**Subject: Vermont Yankee Nuclear Power Station
License No. DPR-28 (Docket No. 50-271)
Technical Specification Proposed Change No. 248
Alternate Train Testing**

Proposed Technical Specification Change No. 248

Alternate Train Testing

Marked-up Version of the Current Technical Specifications

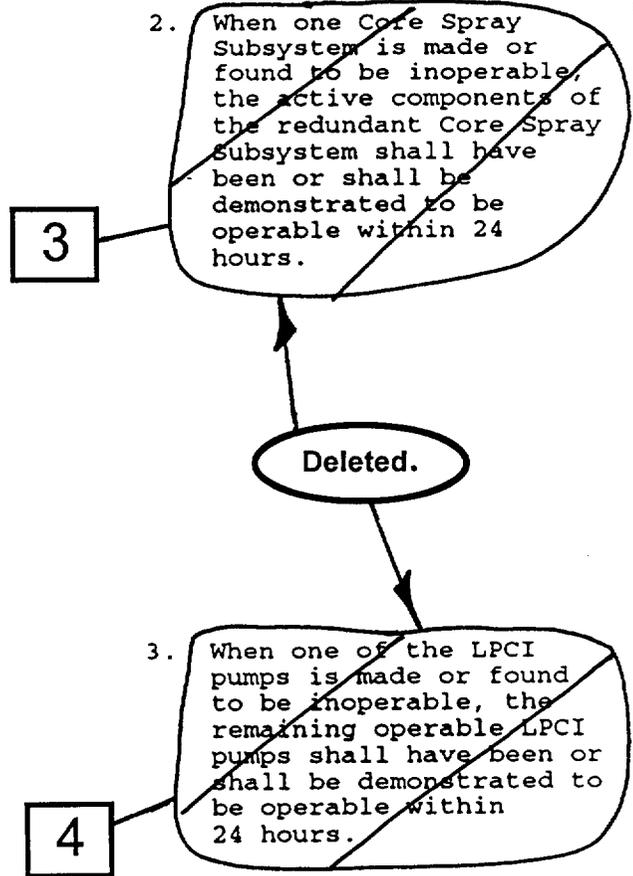
2. From and after the date that one of the Core Spray Subsystems is made or found to be inoperable for any reason, reactor operation is permissible only during the succeeding seven days unless such subsystem is sooner made operable, provided that during such seven days, all active components of the other Core Spray Subsystem, the LPCI Subsystems, and the diesel generators required for operation of such components if no external source of power were available, shall be operable.

3. From and after the date that one of the LPCI pumps is made or found to be inoperable for any reason, reactor operation is permissible only during the succeeding seven days unless such pump is sooner made operable, provided that during such seven days, the remaining active components of the LPCI Containment Cooling Subsystem and all active components of both Core Spray Subsystems and the diesel generators required for operation of such components if no external source of power were available, shall be operable.

Change #	Current Technical Specification	Proposed Change
3	<p>CTS 4.5.A.2 requires that when one core spray subsystem is made or found to be inoperable, the active components of the redundant core spray subsystem shall have been or shall be demonstrated to be operable within 24 hours.</p>	<p>Delete CTS 4.5.A.2 and add the word, "Deleted" in its place.</p>
<p>Basis / Safety Assessment:</p> <p>The core spray (CS) system is required in conjunction with the LPCI subsystems to provide adequate core cooling to the reactor core in the event of a loss of coolant accident (LOCA). The LPCI subsystems are completely independent of the CS systems; however, LPCI does function with CS to prevent excessive fuel clad temperature in accordance with the requirements of 10CFR50, Appendix K.</p> <p>Should one CS subsystem become inoperable, the remaining CS subsystem, LPCI subsystems, and associated emergency diesel generators (EDGs) are required to be operable by Limiting Condition for Operation 3.5.A.2. These systems provide extensive margin to that needed to ensure adequate core cooling. CTS 3.5.A.2 only permits continued reactor operation for up to 7 days with one CS subsystem inoperable, provided that the conditions of CTS 3.5.A.2 are met.</p> <p>Current SR 4.5.A.1, which includes CS testing in accordance with Section XI of the ASME code, provides adequate surveillance to ensure operability of the redundant subsystem. Alternate train testing, which currently must occur within 24 hours of a subsystem being declared inoperable, does not contribute any significant assurance of system operability, and may in fact lead to unintended or premature system failure.</p> <p>This change is therefore acceptable, since adequate assurance of CS system operational readiness is provided through other SRs.</p>

Change #	Current Technical Specification	Proposed Change
4	<p>CTS 4.5.A.3 requires that when one of the low pressure coolant injection (LPCI) pumps is made or found to be inoperable, the remaining operable LPCI pumps shall have been or shall be demonstrated to be operable within 24 hours.</p>	<p>Delete CTS 4.5.A.3 and add the word, "Deleted" in its place.</p>
<p>Basis / Safety Assessment:</p> <p>The LPCI system is required in conjunction with the core spray system to provide adequate core cooling to the reactor core in the event of a loss of coolant accident (LOCA). The LPCI subsystems are completely independent of the CS systems; however, LPCI does function with CS to prevent excessive fuel clad temperature in accordance with the requirements of 10CFR50, Appendix K.</p> <p>Should one LPCI pump become inoperable, the remaining active components of the LPCI system and all active components of both core spray subsystems, and the EDGs are required to be operable by Limiting Condition for Operation 3.5.A.3. These systems provide extensive margin to that needed to ensure adequate core cooling. CTS 3.5.A.3 only permits continued reactor operation for up to 7 days with one LPCI pump inoperable, provided that the conditions of CTS 3.5.A.3 are met.</p> <p>Current SR 4.5.A.1, which includes pump testing in accordance with Section XI of the ASME code, provides adequate surveillance to ensure operability of the redundant subsystem. Alternate train pump testing, which currently must occur within 24 hours of a pump being declared inoperable, does not contribute any significant assurance of system operability, and may in fact lead to unintended or premature pump failure.</p> <p>This change is therefore acceptable, since adequate assurance of LPCI pump operational readiness is provided through other SRs.</p>

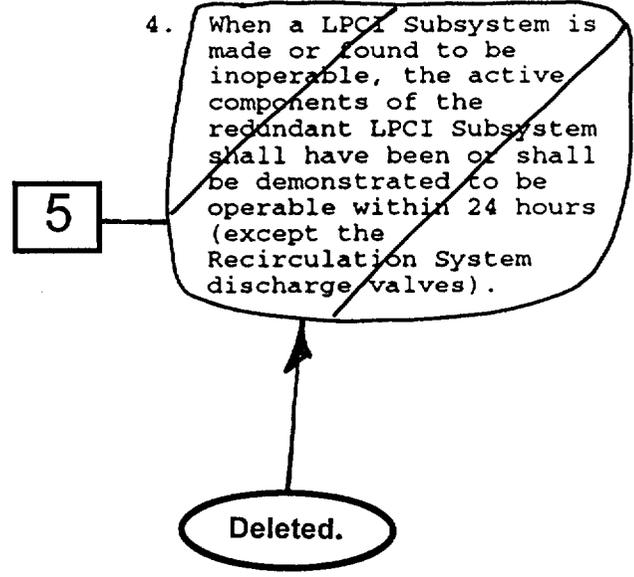
- 4. a. From and after the date that a LPCI Subsystem is made or found to be inoperable due to failure of the associated UPS, reactor operation is permissible only during the succeeding thirty days, for the 1989/90 operating cycle, unless it is sooner made operable, provided that during that time the associated motor control center (89A or 89B) is powered from its respective maintenance tie, all active components of the other LPCI and the Containment Cooling Subsystem, the Core Spray Subsystems, and the emergency diesel generators shall be operable, the requirements of Specification 3.10.A.4 are met, and the 4160 volt tie line to the Vernon Hydro is the operable delayed access power source.

- b. From and after the date that a LPCI Subsystem is made or found to be inoperable for any reason, other than failure of the UPS during the 1989/90 operating cycle, or Specification 3.5.A.4.a is not met, reactor operation is permissible only during the succeeding seven days unless it is sooner made operable, provided

Change #	Current Technical Specification	Proposed Change
5	<p>CTS 4.5.A.4 requires that when a LPCI subsystem is made or found to be inoperable, the active components of the redundant LPCI subsystem shall have been or shall be demonstrated to be operable within 24 hours (except the recirculation system discharge valves).</p>	<p>Delete CTS 4.5.A.4 and add the word, "Deleted" in its place.</p>
<p>Basis / Safety Assessment:</p> <p>The LPCI system is required in conjunction with the core spray system to provide adequate core cooling to the reactor core in the event of a loss of coolant accident (LOCA). The LPCI subsystems are completely independent of the core spray system; however, LPCI does function with CS to prevent excessive fuel clad temperature in accordance with the requirements of 10CFR50, Appendix K.</p> <p>Should one LPCI subsystem become inoperable, the remaining active components of the LPCI system and all active components of both core spray subsystems, and the EDGs are required to be operable by Limiting Condition for Operation 3.5.A.4. These systems provide extensive margin to that needed to ensure adequate core cooling. CTS 3.5.A.4 only permits continued reactor operation for up to 7 days with one LPCI subsystem inoperable, provided that the conditions of CTS 3.5.A.4 are met.</p> <p>Current SR 4.5.A.1, which includes testing in accordance with Section XI of the ASME code, provides adequate surveillance to ensure operability of the redundant subsystem. Alternate train testing, which currently must occur within 24 hours of a subsystem being declared inoperable, does not contribute any significant assurance of system operability, and may in fact lead to unintended or premature system failure.</p> <p>This change is therefore acceptable, since adequate assurance of LPCI system operational readiness is provided through other SRs.</p>

C. Residual Heat Removal (RHR) Service Water System

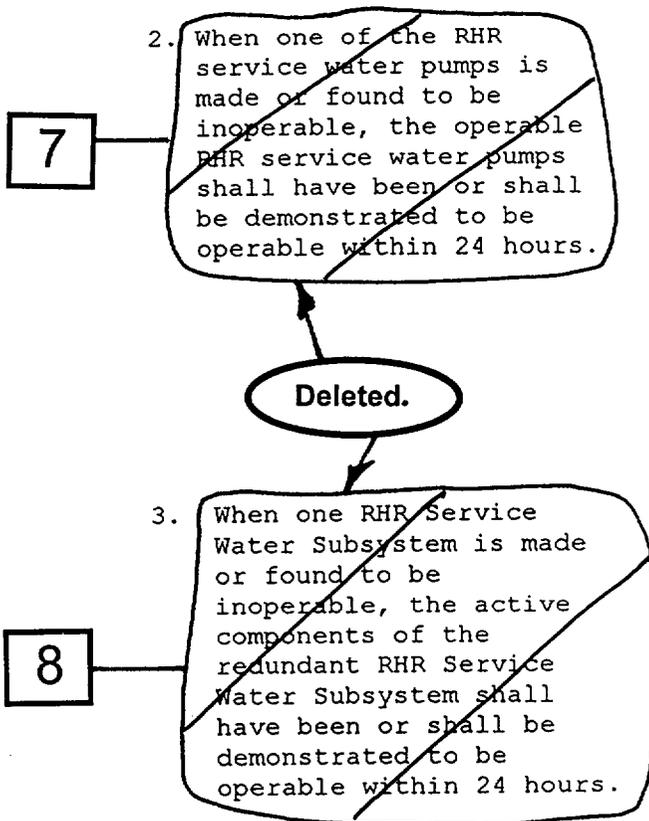
2. From and after the date that one of the RHR service water pumps is made or found to be inoperable for any reason, reactor operation is permissible only during the succeeding thirty days unless such pump is sooner made operable, provided that during such thirty days all other active components of the RHR Service Water Subsystem are operable.

3. From and after the date that one RHR Service Water Subsystem is made or found to be inoperable for any reason, reactor operation is permissible only during the succeeding seven days unless such subsystem is sooner made operable, provided that all active components of the other RHR Service Water

Change #	Current Technical Specification	Proposed Change
7	<p>CTS 4.5.C.2 requires that when one of the residual heat removal (RHR) service water pumps is made or found to be inoperable, the operable RHR service water pumps shall have been or shall be demonstrated to be operable within 24 hours.</p>	<p>Delete CTS 4.5.C.2 and add the word, "Deleted" in its place.</p>
<p>Basis / Safety Assessment:</p> <p>CTS 4.5.C.2 requires that the remaining RHR service water pumps be demonstrated to be operable within 24 hours of determining inoperability of one RHR service water pump. This change precludes performing unnecessary pump testing and will allow credit to be taken for normal periodic surveillance as a verification of operability and availability of the remaining RHR service water pumps. Assurance that the other RHR service water pumps will perform their intended safety function is obtained from the results of the testing performed in accordance with the VY IST program, as required by SR 4.5.C.1 and SR 4.6.E.2. This periodic and post-maintenance testing is adequate to ensure system operability.</p> <p>This change is acceptable because existing SR 4.5.C.2 only provides marginal assurance of system operability, and may in fact have an overall cumulative negative effect on plant safety.</p>

Change #	Current Technical Specification	Proposed Change
8	<p>CTS 4.5.C.3 requires that when one RHR service water subsystem is made or found to be inoperable, the active components of the redundant RHR service water subsystem shall have been or shall be demonstrated to be operable within 24 hours.</p>	<p>Delete CTS 4.5.C.3 and add the word, "Deleted" in its place.</p>
<p>Basis / Safety Assessment:</p> <p>CTS 4.5.C.3 requires that the active components of the redundant RHR service water subsystem be demonstrated to be operable within 24 hours of determining inoperability of one RHR service water subsystem. This change precludes performing unnecessary component testing and will allow credit to be taken for normal periodic surveillance as a verification of operability and availability of the remaining RHR service water subsystem. Assurance that the active components of the redundant RHR service water subsystem will perform their intended safety function is obtained from the results of component testing performed in accordance with the VY IST program, as required by SR 4.6.E.2. and SR 4.5.C.1. This periodic and post-maintenance testing is adequate to ensure system operability.</p> <p>This change is acceptable because existing SR 4.5.C.3 only provides marginal assurance of system operability, and may in fact have an overall cumulative negative effect on plant safety.</p>

12

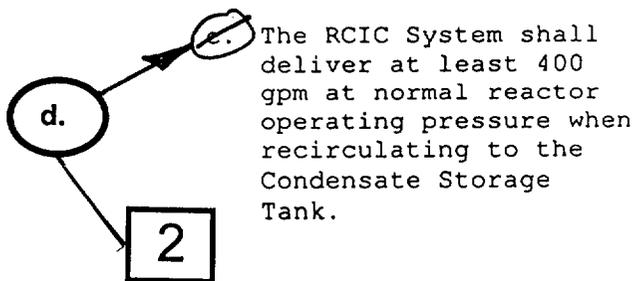
2. ~~When one relief valve of the Automatic Pressure Relief Subsystem is made or found to be inoperable, the HPCI Subsystem shall have been or shall be demonstrated to be operable within 24 hours.~~

Change #	Current Technical Specification	Proposed Change
12	<p>CTS 4.5.F.2 requires that when one relief valve of the automatic pressure relief system is made or found to be inoperable, the HPCI subsystem shall have been or shall be demonstrated to be operable within 24 hours.</p>	<p>Delete CTS 4.5.F.2 and add the word, "Deleted" in its place.</p>
<p>Basis / Safety Assessment:</p> <p>CTS 4.5.F.2 requires that the HPCI System be demonstrated to be operable within 24 hours of determining that one relief valve of the automatic pressure relief subsystem is inoperable. This change precludes performing unnecessary component testing and will allow credit to be taken for normal periodic surveillance as a verification of operability and availability of the HPCI system. Assurance that HPCI will perform its intended safety function is obtained from the results of component testing performed in accordance with the VY IST program, as required by SR 4.6.E.2. and SR 4.5.E.1. This periodic and post-maintenance testing is adequate to ensure system operability.</p> <p>This change is acceptable because existing SR 4.5.F.2 only provides marginal assurance of system operability, and may in fact have an overall cumulative negative effect on plant safety.</p>

B. Operation With Inoperable Components

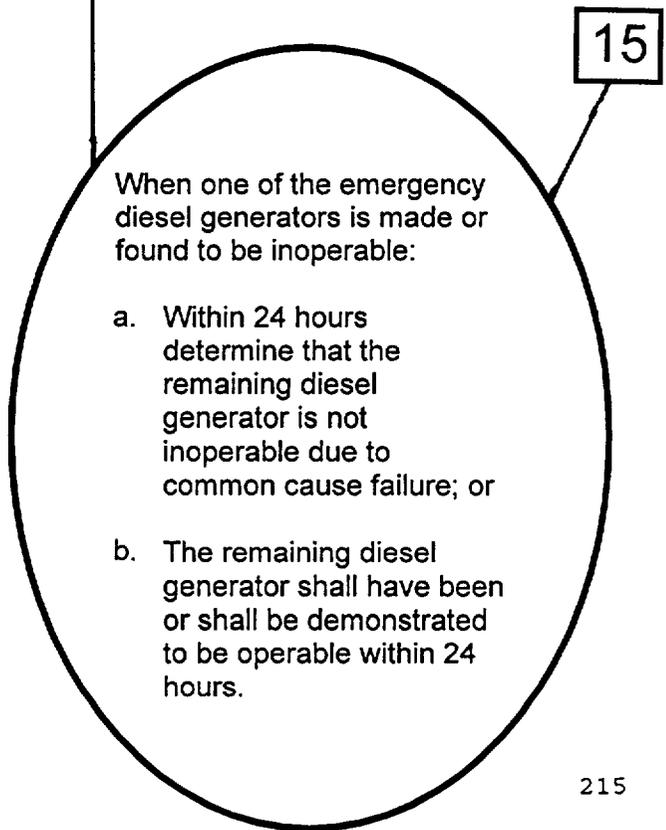
1. Diesel Generator

Change #	Current Technical Specification	Proposed Change
15	<p>CTS 4.10.B.1 specifies that when one of the diesel generators is made or found to be inoperable, the requirements of Specification 4.5.H.1 shall be satisfied.</p>	<p>Revise TS 4.10.B.1 to require:</p> <p><i>When one of the emergency diesel generators is made or found to be inoperable:</i></p> <ul style="list-style-type: none"> <i>a. Within 24 hours determine that the remaining diesel generator is not inoperable due to common cause failure; or</i> <i>b. The remaining diesel generator shall have been or shall be demonstrated to be operable within 24 hours.</i>

15	<p>Basis / Safety Assessment:</p> <p>The requirement for EDG testing when one of the EDGs is made or found to be inoperable is currently contained in CTS 4.5.H.1. This requirement is being relocated to TS 4.10.B.1 and further modified as described herein. (See also change #13 above.)</p> <p>CTS 4.5.H.1 requires that the remaining EDG be demonstrated to be operable within 24 hours of determining that one EDG is inoperable. This modification of the requirement precludes performing unnecessary EDG testing and will allow credit to be taken for normal periodic surveillance as a verification of operability and availability of the EDGs when it can be determined within 24 hours that the cause of the failure of the first EDG does not exist for the other EDG. If this condition is met, assurance that the remaining EDG will perform its intended safety function is obtained from the results of EDG testing performed as required by SR 4.10.A. This periodic testing is adequate to ensure system operability, provided that a common cause failure does not exist.</p> <p>This change is acceptable because, if it is known that a common cause failure of the EDG does not exist, current SR 4.5.H.1 only provides marginal assurance of system operability, and may in fact have an overall cumulative negative effect on plant safety.</p> <p>Proposed TS 4.10.B.1 provides an allowance to avoid unnecessary testing of the operable EDG. If it can be determined that the cause of the inoperable EDG (e.g., removal from service to perform routine maintenance or testing) does not exist on the operable EDG, demonstration of operability of the remaining EDG does not have to be performed. If the cause of inoperability exists on the remaining EDG, it is declared inoperable upon discovery, and Limiting Condition for Operation 3.5.H.1 requires reactor shutdown within 24 hours. Once the failure is repaired, and the common cause failure no longer exists, revised TS 4.10.B.1 is satisfied. If the cause of the initial inoperable EDG cannot be confirmed not to exist on the remaining EDG, performance of new SR 4.10.B.1.b suffices to provide assurance of continued operability of that EDG.</p> <p>In the event the inoperable EDG is restored to operable status prior to completing either new SR 4.10.B.1.a or new SR 4.10.B.1.b, the plant corrective action program will continue to evaluate the common cause possibility. This continued evaluation, however, is no longer under the 24 hour constraint imposed while in the condition of SR 4.10.B.1. According to NRC Generic Letter 84-15, 24 hours is a reasonable time to confirm that the operable EDG is not affected by the same problem as the inoperable EDG.</p> <p>These clarifications are included in the revised TS Bases and are consistent with STS.</p> <p>This change is therefore acceptable because it provides adequate assurance of operability of the remaining EDG when one EDG is made or found to be inoperable.</p>
